Assessment of Drainage Proposals

55 Fitzroy Park, Camden

January 2021

Figure 5 - TREE REMOVAL PLAN OVERLAID ONTO DRAINAGE LAYOUT

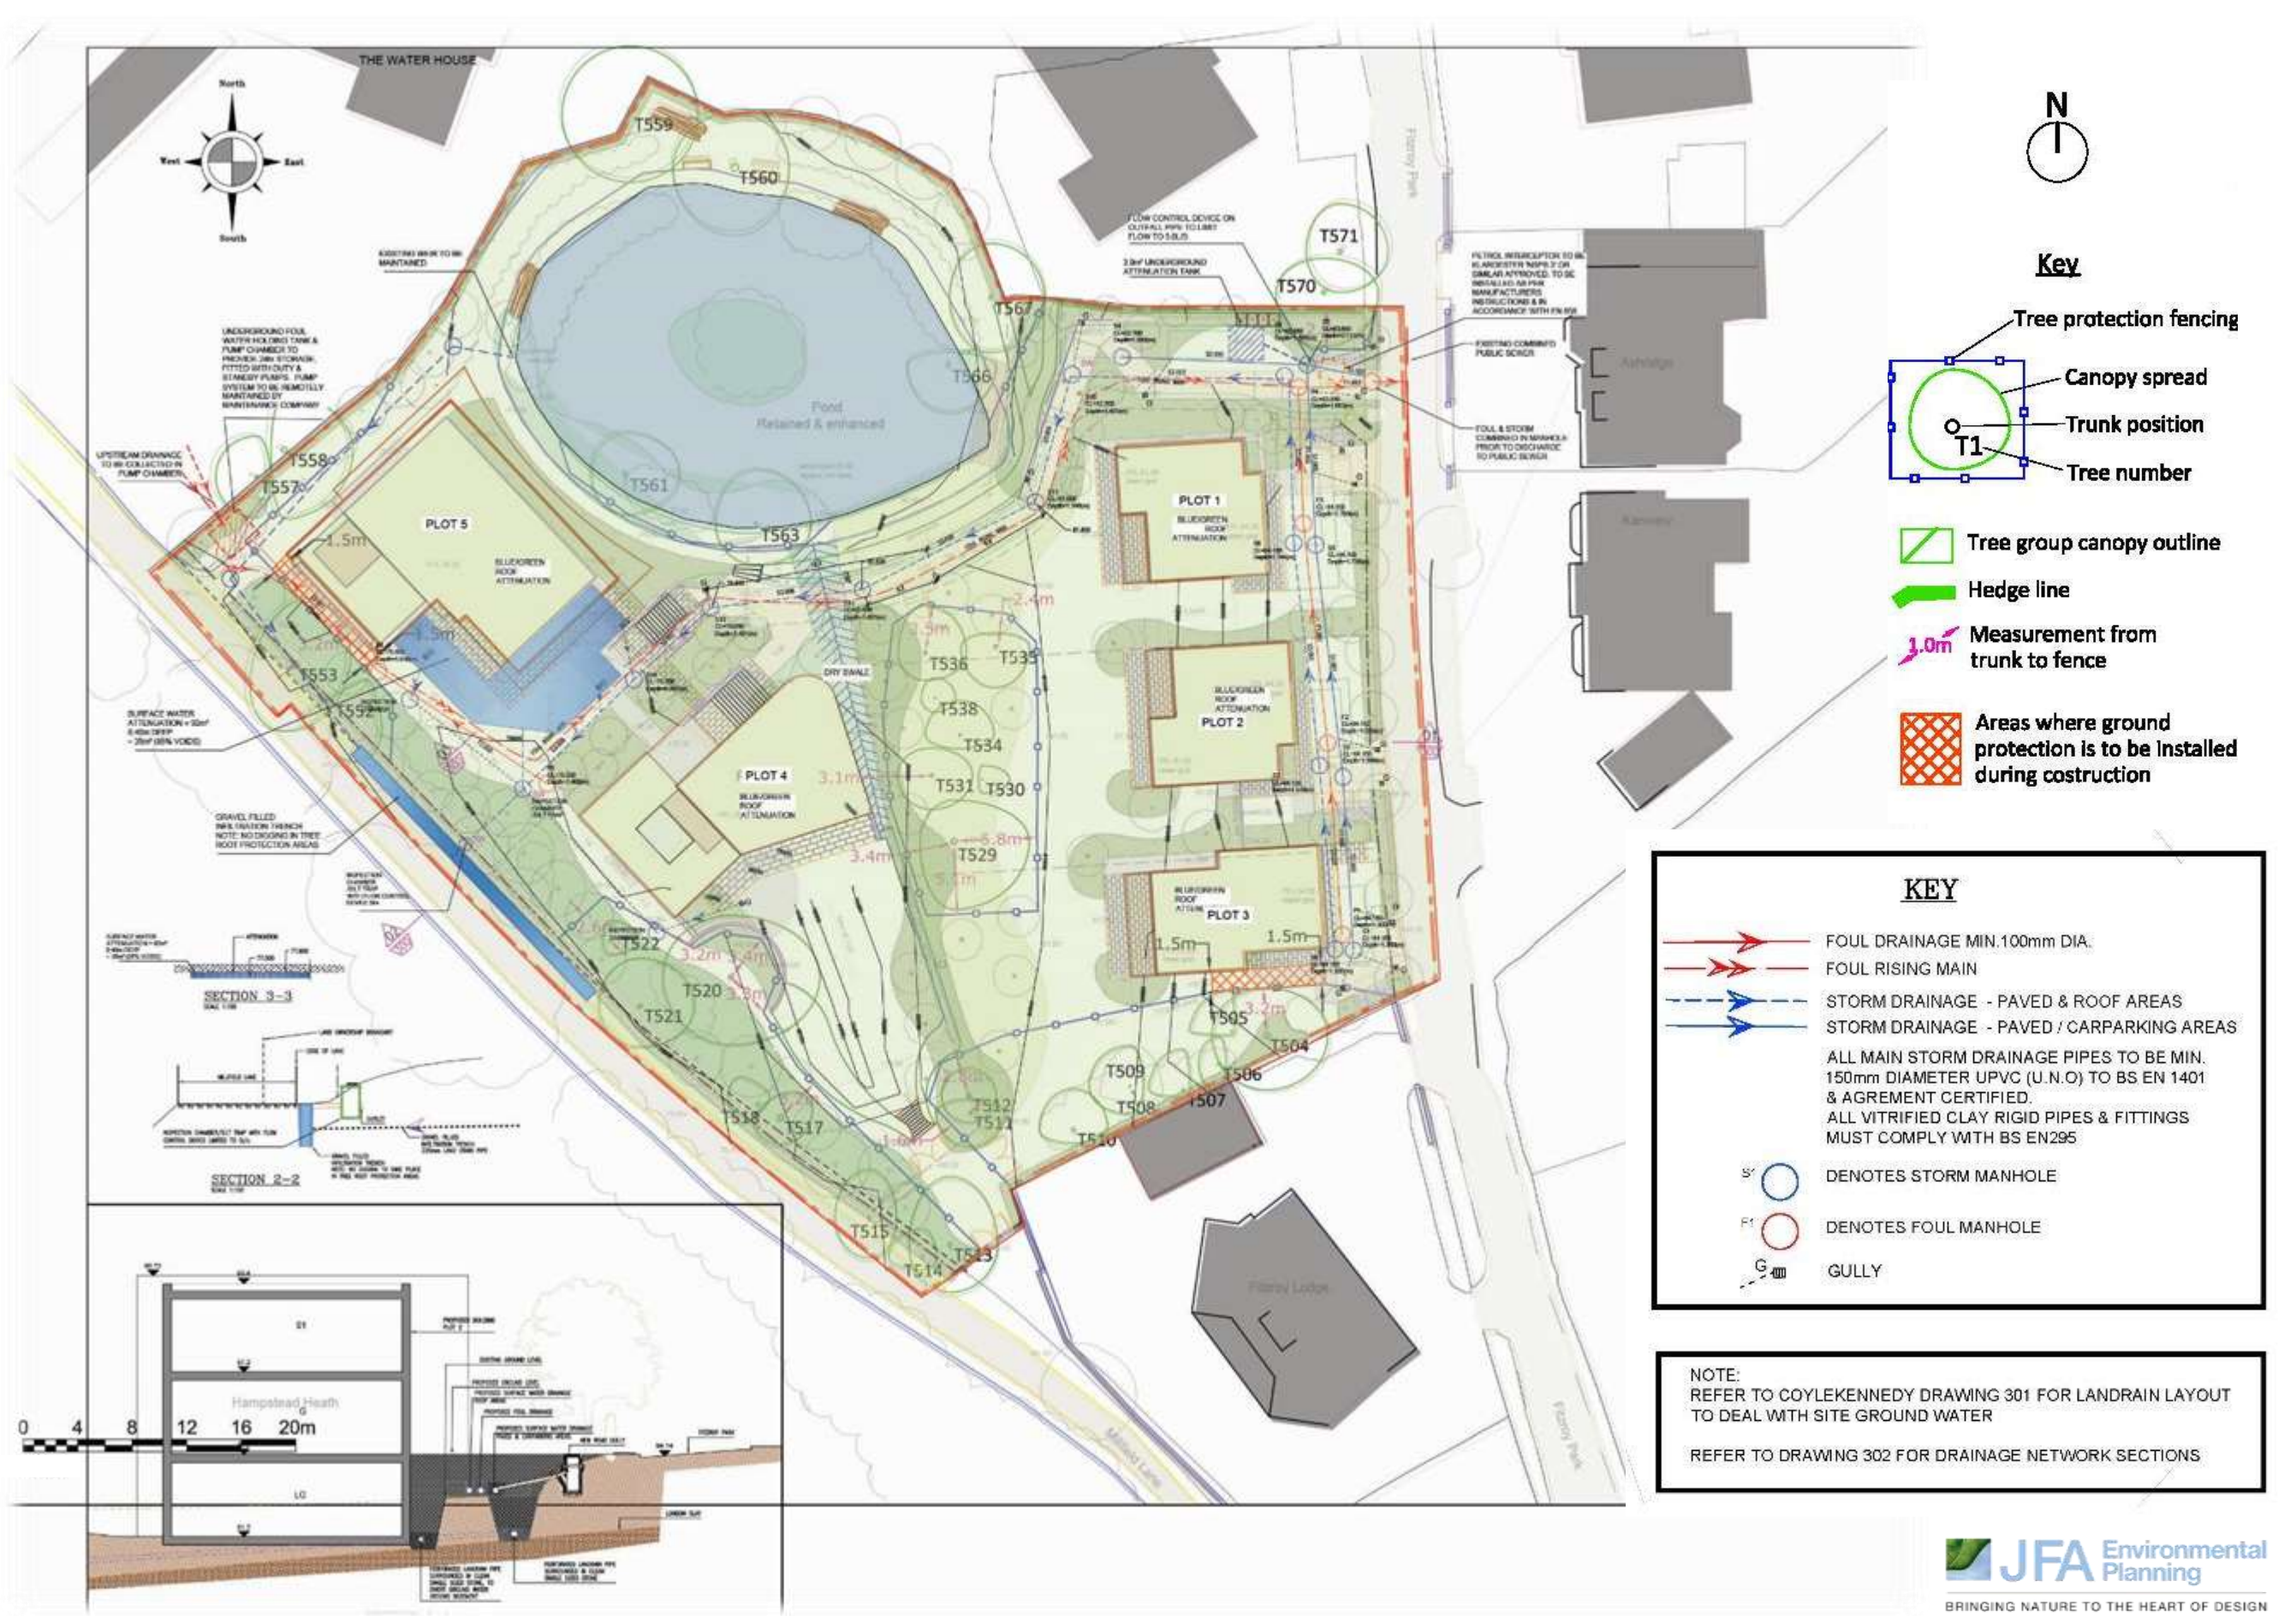
Some existing trees also have the potential to grow much larger in the future and as a result their roots could grow into the easement corridors of the proposed sewer runs.

Figure 6 -TREE PROTECTION PLAN OVERLAID ONTO DRAINAGE LAYOUT

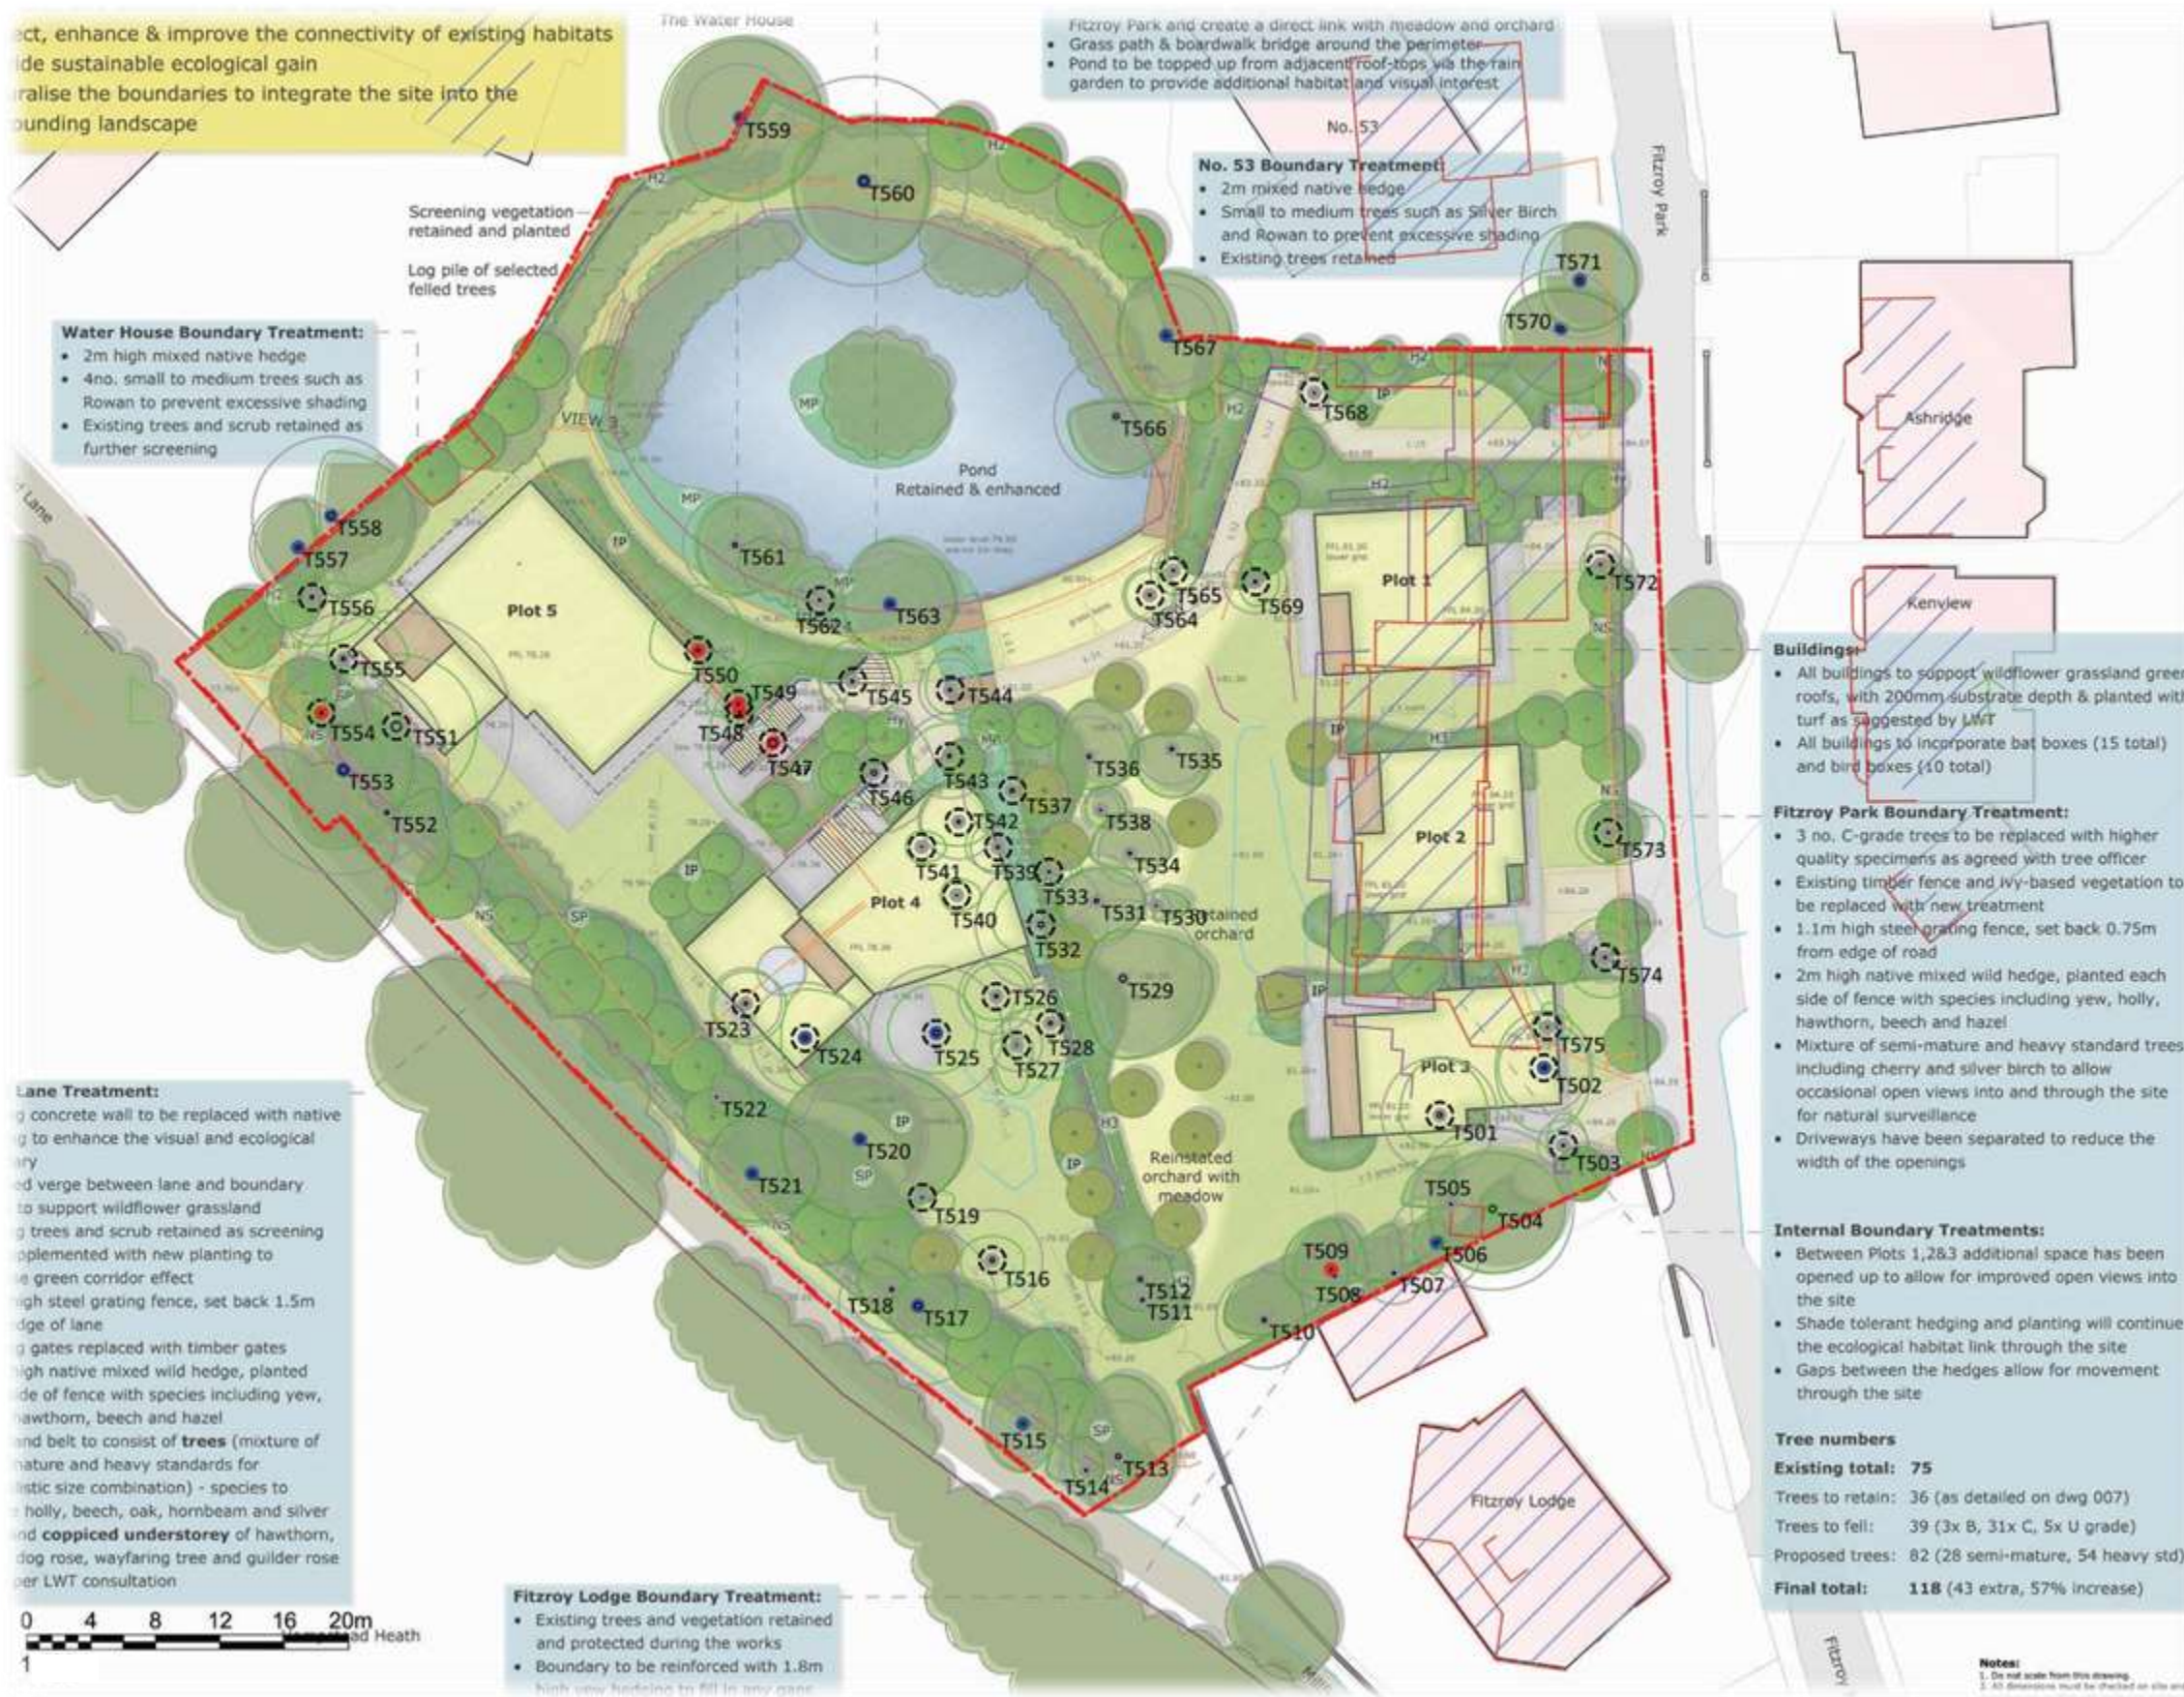
Existing trees on site - Identified Conflicts						
Proposal	Tree Numbers	Species	Current Canopy (maximum reach)	Potential canopy spread	Conflict	Reference
Gravel/infill trench pipework to the south of plot 5	T552	Hawthorn	5m	4-8m	Pipework runs through RPA of tree	See Figure 6 of JFA overlays
	T553	Sycamore	5m	10-25m	Pipework runs through RPA of tree	
	Trees in neighbouring land to south of site	Unknown	Unknown	Unknown	They may have RPAs that extend into the site where the gravel trench and pipework is proposed	
Foul water holding tank and pump chamber on north-western corner of site	T557	Eucalyptus	3m	7-15m	Within RPA of tree	
Storm drain pipework between the existing weir and the gravel trench	T557	Eucalyptus	3m	7-15m	Pipework runs through RPA of tree	
	T558	Eucalyptus	5m	7-15m	Pipework runs through RPA of tree	
Foul and storm drains running alongside and behind plots 1 and 4	T536	Apple	3.5m	4-8m	Tree canopy and roots could potentially enter the easement area

The overlay of the Tree Protection Plan onto the Proposed Drainage Layout highlights several existing trees that are to be retained whose canopy / root protection areas will be directly affected by the drainage proposals.
